Agenda Item	6.7
Report No	PLN/053/25

## HIGHLAND COUNCIL

**Committee:** North Planning Applications Committee  
**Date:** 06.08.2025  
**Report Title:** 25/01063/FUL                      Mr & Mrs William & Marlene Lipka  
                                  15 Riverside Place  
                                  Thurso  
                                  KW14 8BZ

**Description:** Extension and change of use from house to paint & decoration supply business (in retrospect)  
**Ward:** 02 - Thurso And North West Caithness  
**Development category:** Local  
**Reason referred to Committee:** called in by local Ward Members

PLANNING PROPOSAL DRAWINGS  
Proposed Attic Floor Plan & Elevations

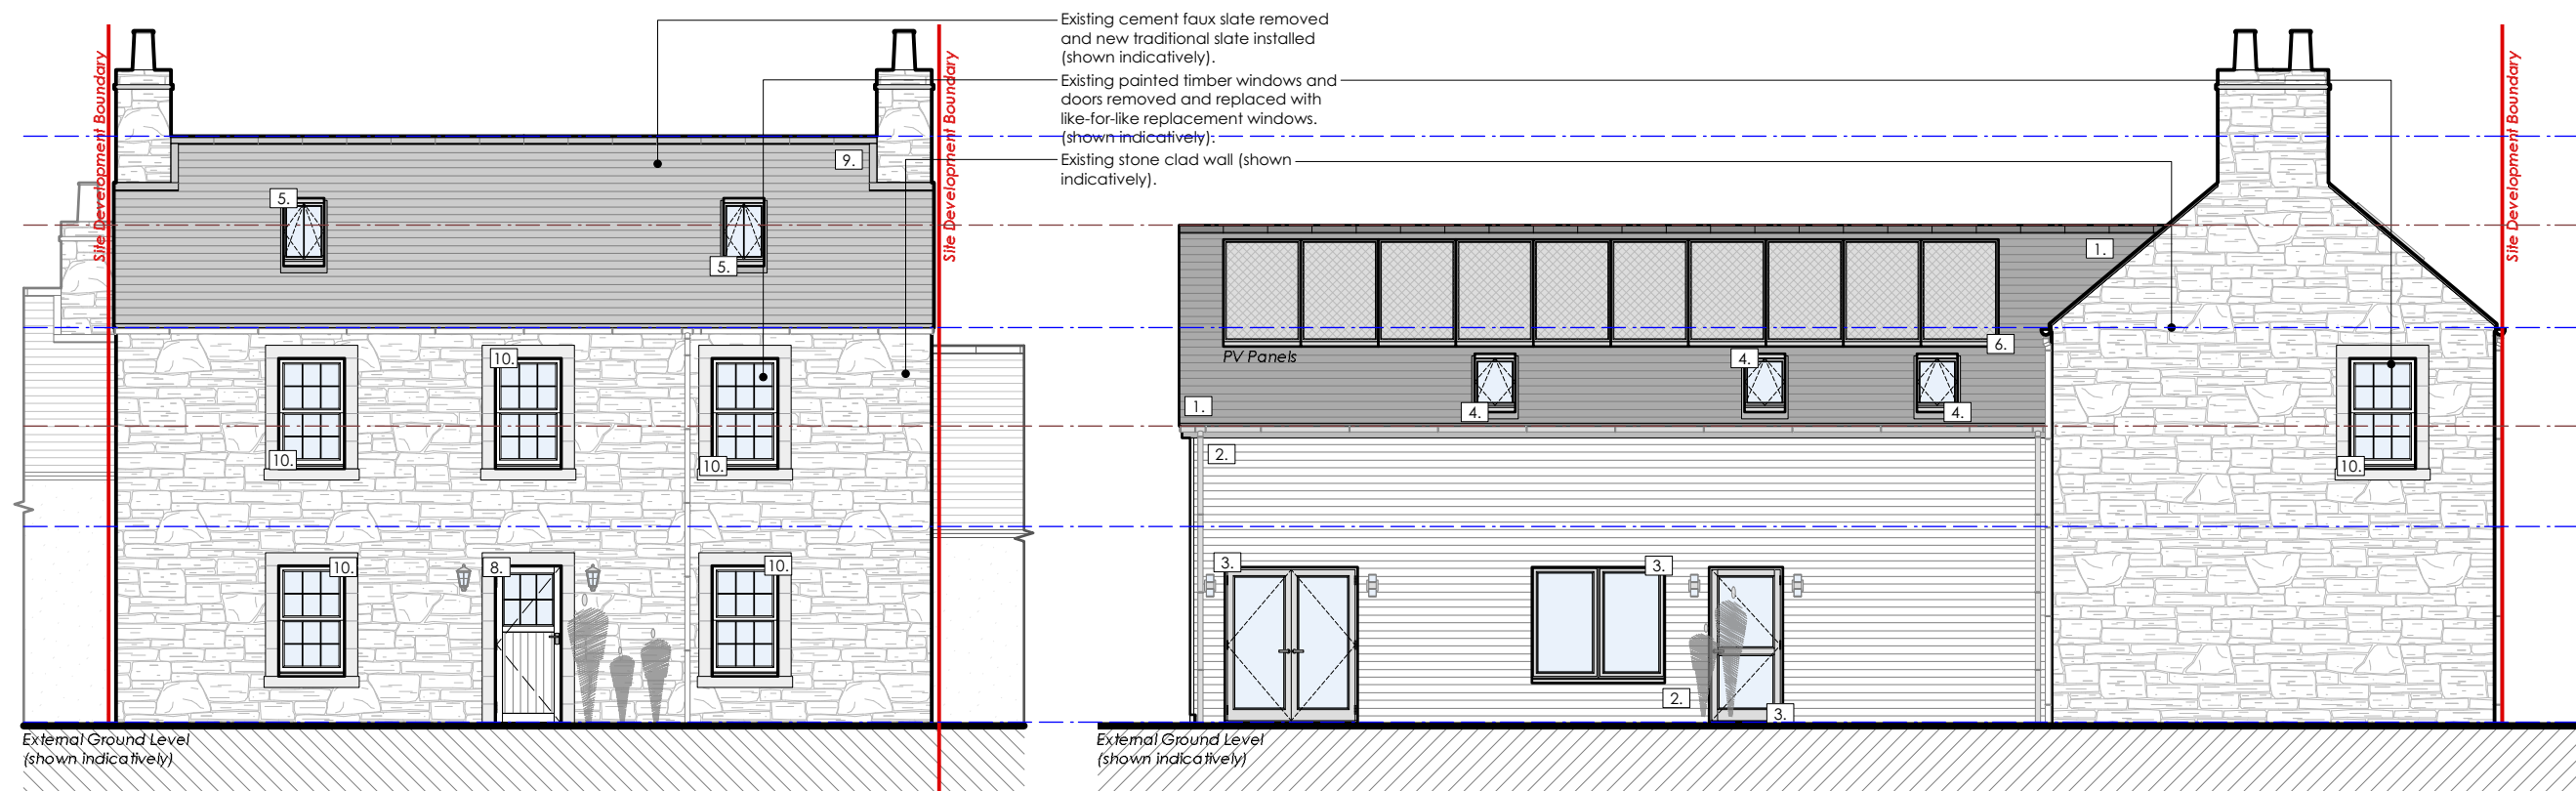
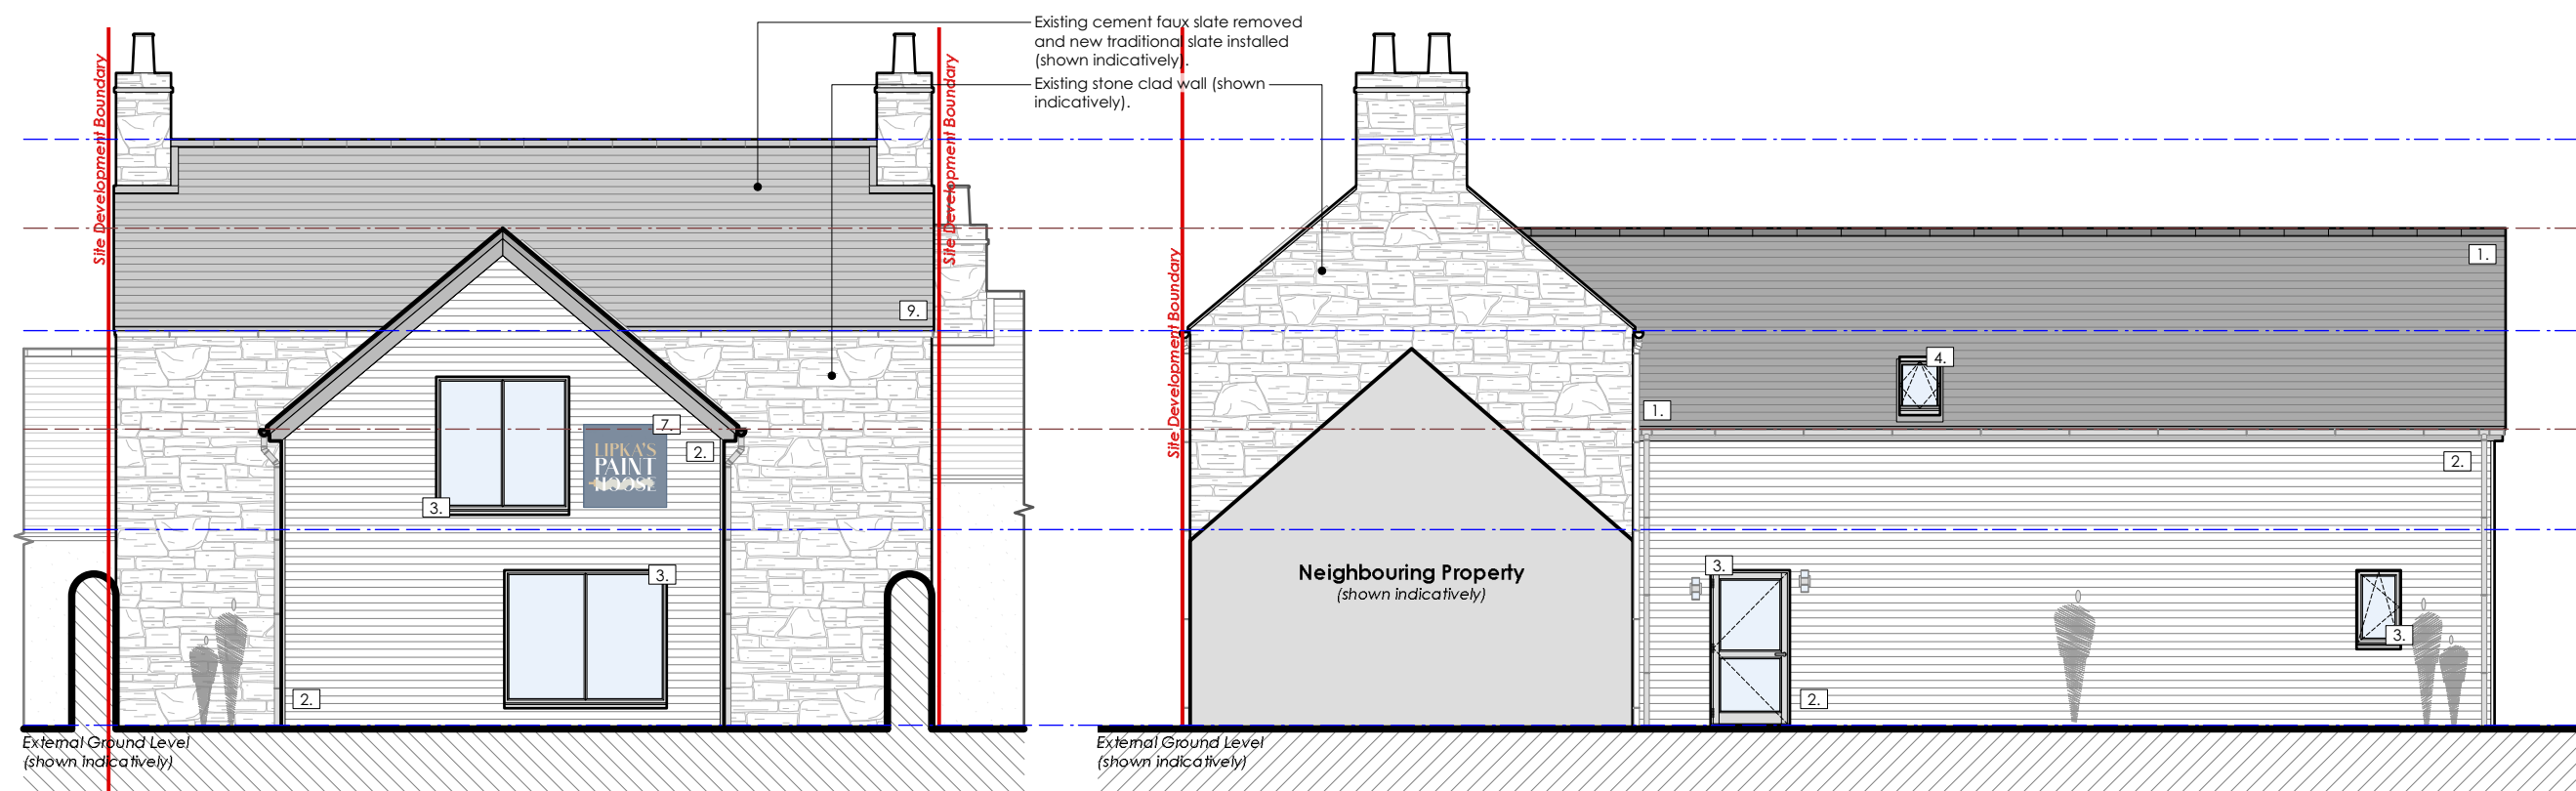
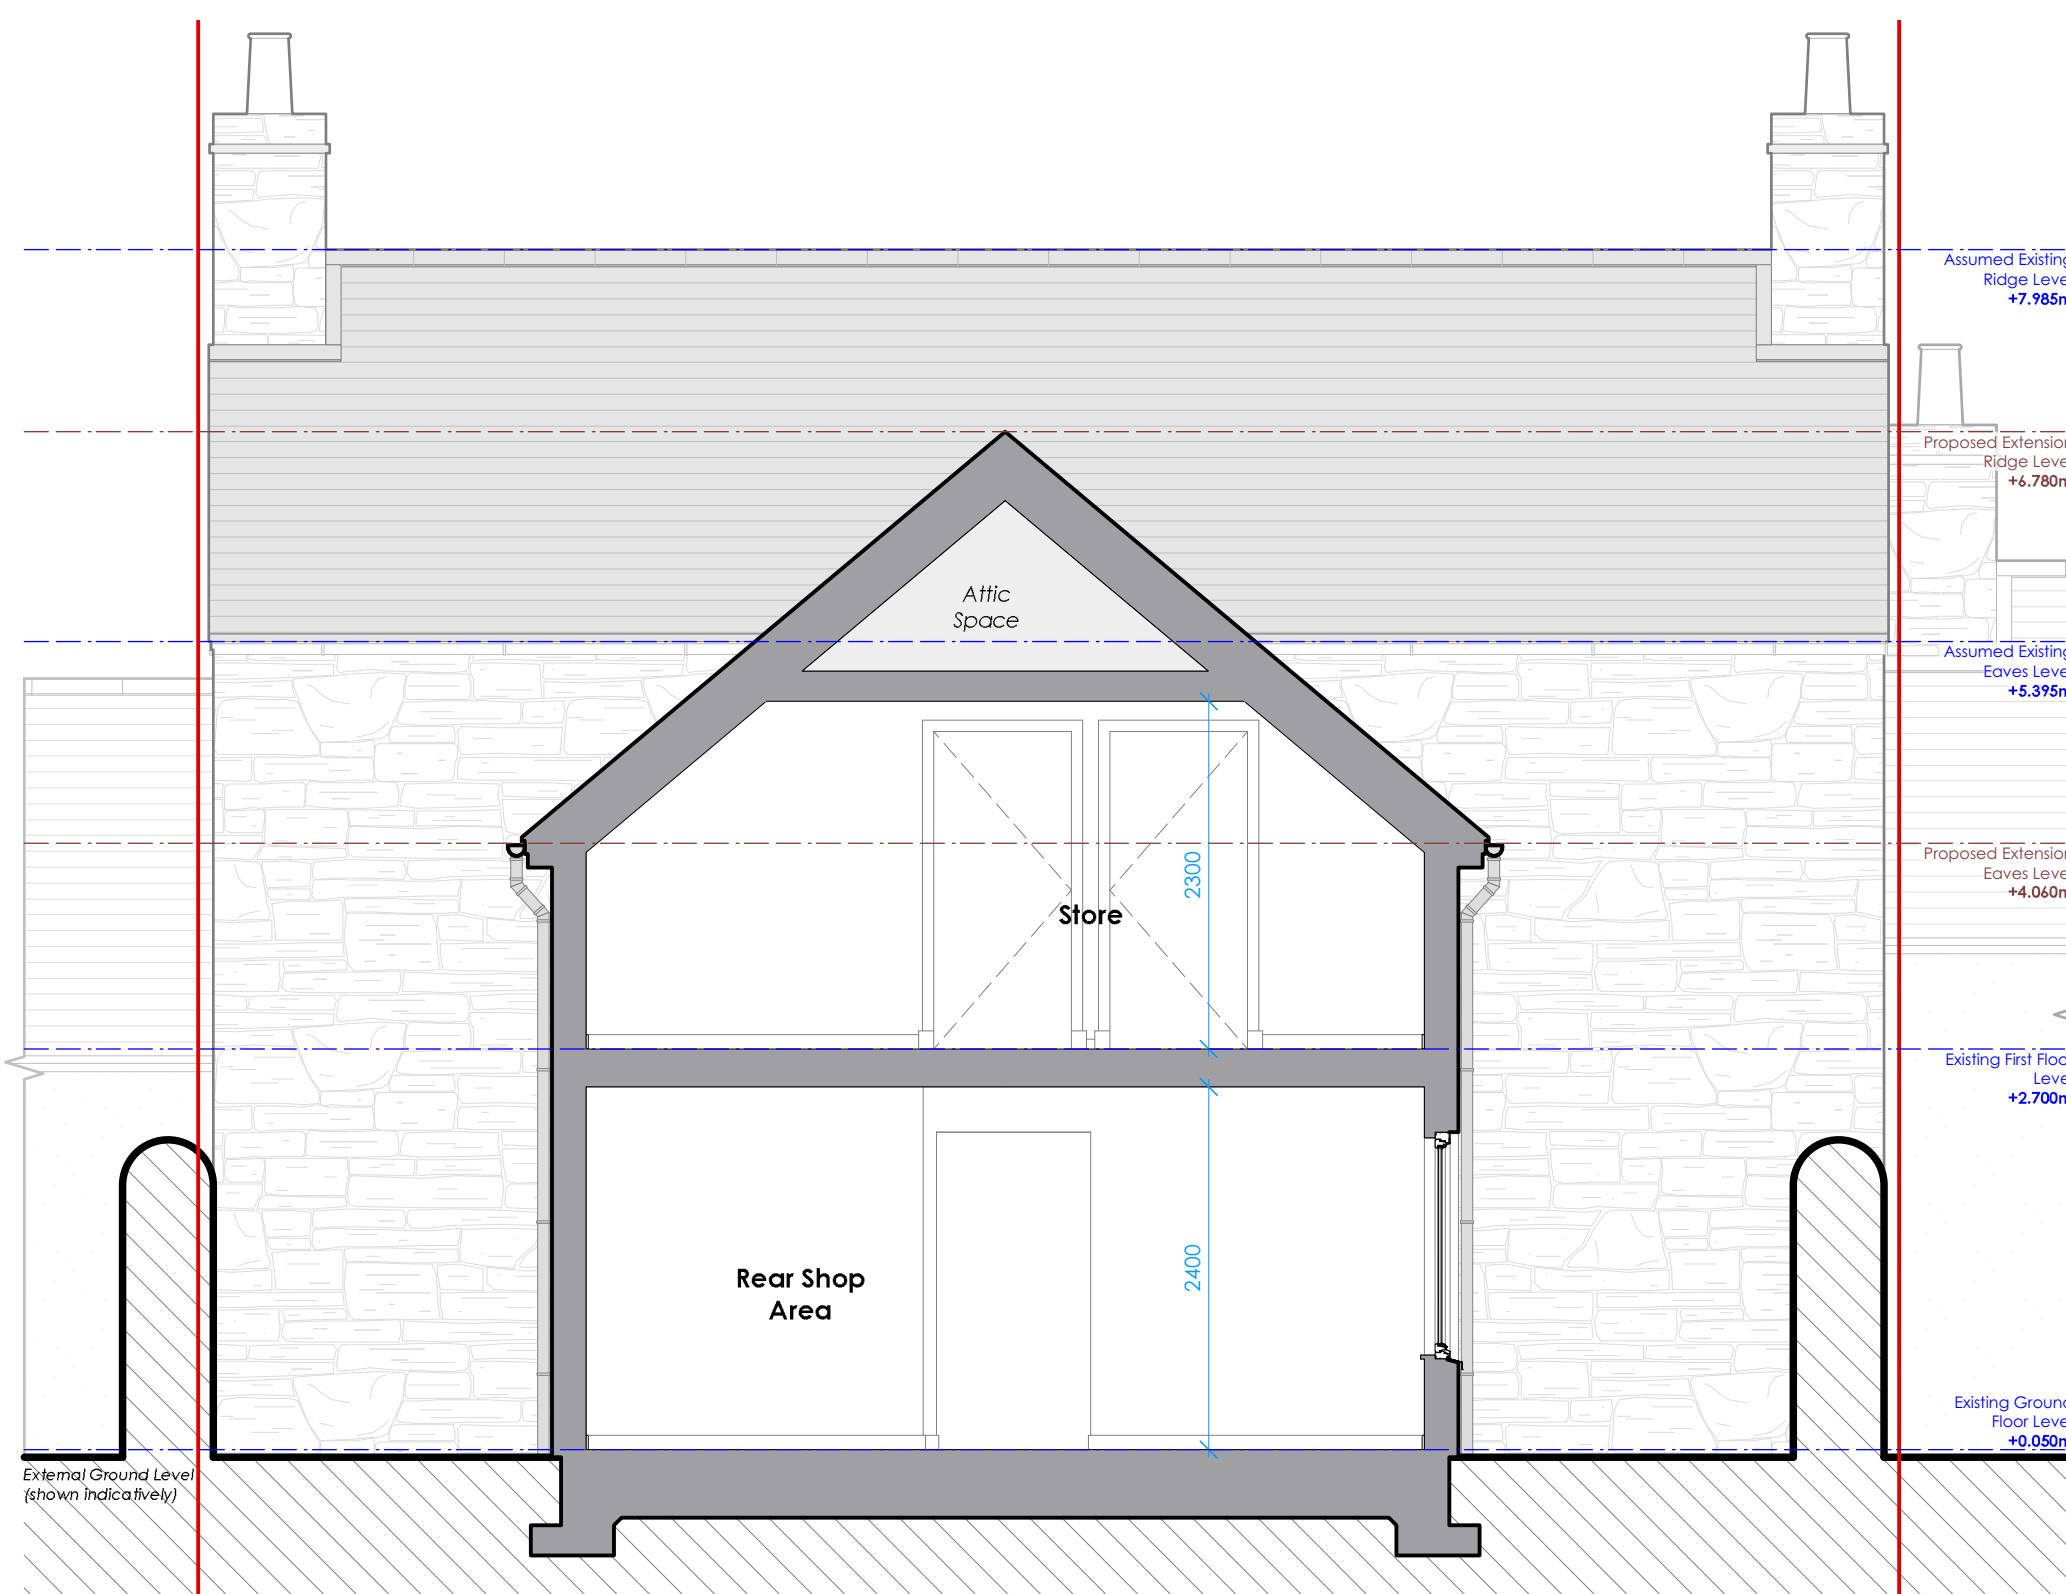
- 8.9 As the incorporation of white horizontal Cedral cladding is both inappropriate and unacceptable in relation to a statutorily-designated built heritage asset, the Planning Authority requires the applicant to remove the existing cladding and instead apply a traditional lime render finish to a suitable substrate – this option is considered both suitably respectful to the historic built environment and sufficiently fire-retardant. This suggestion is however offered without prejudice to any subsequent assessment by the Building Standards Authority; an amendment to the current Building Warrant would be necessary. A lime render would be expected to be off-white/putty/oatmeal coloured, which would be more visually recessive and subservient to the original listed building than bright white cladding.

historic environment perspective. The constructed extension's windows depart from this significantly, being of an anthracite grey colour. The exact window frame material appears to be of woodgrain-effect uPVC, rather than of timber as approved.

- 8.12 The size, scale and number of windows are also considered to be problematic in their non-compliance with approved plans, as set out above fully in section 1.3. The constructed extension's rear elevation features one additional window to that as approved, due to the unauthorised construction of an upper storey. The exact arrangement of a central upper window juxtaposed with a slightly wider, off-centred window below is not considered to be of sufficient quality in relation to a listed building. Although the approved plans include vertically proportioned windows, a single ground-floor opening within an otherwise timber-clad elevation is considered the more modest and appropriate solution for a commercial-use extension to a listed building. Attention is furthermore drawn to supplementary guidance set out in 'Historic Windows and Doors' (2017):

The configuration and dimensions of existing windows are however not supported – a series of grills and astragals on approved drawings acted as an appropriate acknowledgement to the 12-pane glazed windows within the listed building's principal elevation. The constructed extension's windows are less contextual, bisected only by one central astragal. They are considered to be excessively generous in size and require to be reduced in scale to be more in keeping with the original listed building.

- i. The rear extension is significantly taller than approved by 1.1 metres resulting in the creation of an another storey
- ii. The installation of inappropriate external timber wall cladding
- iii. The windows and doors are finished in wood grain effect uPVC
- iv. The windows and doors by virtue of their number and size do not accord with the approved plans

<b>As approved (2021)</b>	<b>As constructed</b>	<b>Changes required by Planning Authority</b>
<b>North-west, ground-floor window</b>	Single landscape window	Full-height window with central astragal	Position acceptable; timber 'conservation' style window however required
<b>North-west, first- floor window</b>	(N/A – single- storey extension approved)	Full-height window with central astragal	To be removed – unnecessary for a 'store' area
<b>North-west gable</b>	Linear, horizontal	Square sign	Refer to 'Shopfront

<b>signage</b>	sign across centre	installed to one side of first-floor window	Design Guide' SG
<b>South-west double doors</b>	Double doors		Position acceptable; timber doors are required
<b>South-west single door</b>	Single door adjacent to double doors	Door relocated southward, swapped position with central window	Position acceptable; timber door however required
<b>South-west central window</b>	4 x 2 paned landscape window	2 x 1 window with central astragal	4 x 2 paned (timber) landscape window
<b>South-west additional window</b>	4 x 2 paned landscape window	Not implemented	Optional
<b>South-west rooflights</b>	Two rooflights, widely spaced	Two rooflights, towards centre	Two rooflights, widely spaced
<b>Window frames</b>	Timber, painted white	Grey woodgrain-effect uPVC	Timber 'conservation' style windows
<b>External wall finish</b>	Natural vertically-laid larch cladding	Horizontally-laid white Cedral cladding	Buff-coloured lime harl on substrate

<b>Roof ridge height and creation of an additional upper storey</b>	5.4 metres	6.75 metres	Reduction in height to 5.4 metres

2.	The external appearance of the constructed extension has resulted in an adverse impact on a Category 'C' listed building, by incorporating a series of large uPVC-framed windows. The form of these windows is unacceptable, as they do not take the existing listed building's windows into account – their landscape orientations are broken up by only single astragals, in contrast to the paned appearance of the existing listed building's windows. Their design fails to preserve the building's special architectural or historic interest and departs from the approved Listed Building Consent. Accordingly, it is contrary to NPF4 Policy 7, HwLDP Policies 28, 29 and 57, and to the statutory duty under Section 14 of the Planning (Listed Buildings and Conservation Areas) (Scotland) Act 1997 to have "special regard to the desirability of preserving the building or its features of special architectural or historic interest".

3.	The external appearance of the constructed extension has resulted in an adverse impact on a Category 'C' listed building, by unlawfully incorporating an additional storey in a departure from granted Listed Building Consent. The height of the constructed extension breaches the eaves of the existing listed building, conveying an unbalanced and awkward appearance. Its scale and massing fail to preserve the listed building's special architectural or historic interest contrary to NPF4 Policy 7, HwLDP Policies 28, 29 and 57 and section 14 of the Planning (Listed Buildings and Conservation Areas) (Scotland) Act 1997.
----	---
